# Technical Bulletin

Bulletin No: TCH-003-053

Subject: **BENDIX® TR-3™ INVERSION VALVE RECALL (P/N 101450)**

**Bendix® TR-3™ Inversion Valve  
(part number shown on  
the valve 101450)**

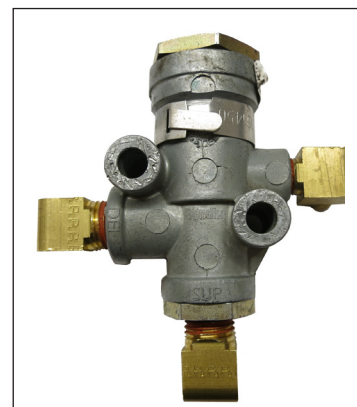
Bendix Commercial Vehicle Systems LLC is conducting a voluntary safety recall campaign, **Recall No.: 15E021**, involving the Bendix® TR-3™ inversion valve (part number 101450 shown on the valve). This includes TR-3 valve part numbers **101450**, **101450N** and **101450R** manufactured between February 6 and October 15, 2014 inclusive.

The valves affected are TR-3™ valves with a casting date code of “13” and assembly date codes B0614T (February 6, 2014) to K1514T (October 15, 2014) inclusive. Products outside the date code range, or valve bodies made with a casting date code other than “13” *are not* affected. See how to identify if the valve is a part of the recall campaign on page three (3) of this bulletin.

Immediately stop using and/or selling any of the TR-3 valves that fall within the recall parameters. It is a violation of Federal law for a dealer or distributor to sell a valve that is subject to this recall. Bendix has a permanent remedy kit (K123677) which is available for you – complete with instructions – to replace any affected TR-3 inversion valves. This remedy is a no cost solution to you. Also, make sure your customers are aware of the recall campaign.

### Valve Identification

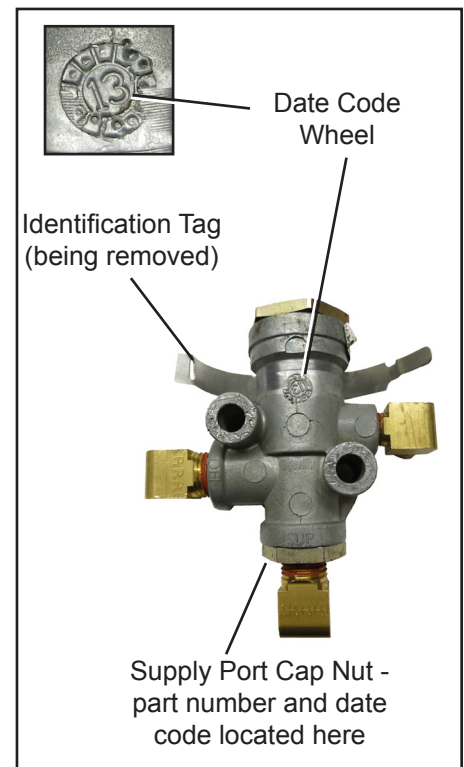
1. **The TR-3 valve covered by this recall should have an identification tag with “SPECIAL TR-3 REPLACE WITH 101450” stamped into it.** This tag may need to be removed from the valve if the view is obstructed. All other part numbers referenced are not a part of the campaign.
2. **Under the identification tag is the valve casting date code wheel. Only body castings with a number 13 in the center are a suspect valve.** Valve bodies that have a number other than 13 are not a part of the campaign.

The valves that are suspect must be removed to verify the part number and the date of manufacture—stamped into the supply port cap nut. To view this information the valve cap nut area must be cleaned of paint and debris. To verify the date code see *Interpreting the Date Code* below.

**Action required. Contact your OEM dealer to schedule the replacement of your TR-3 valve.**
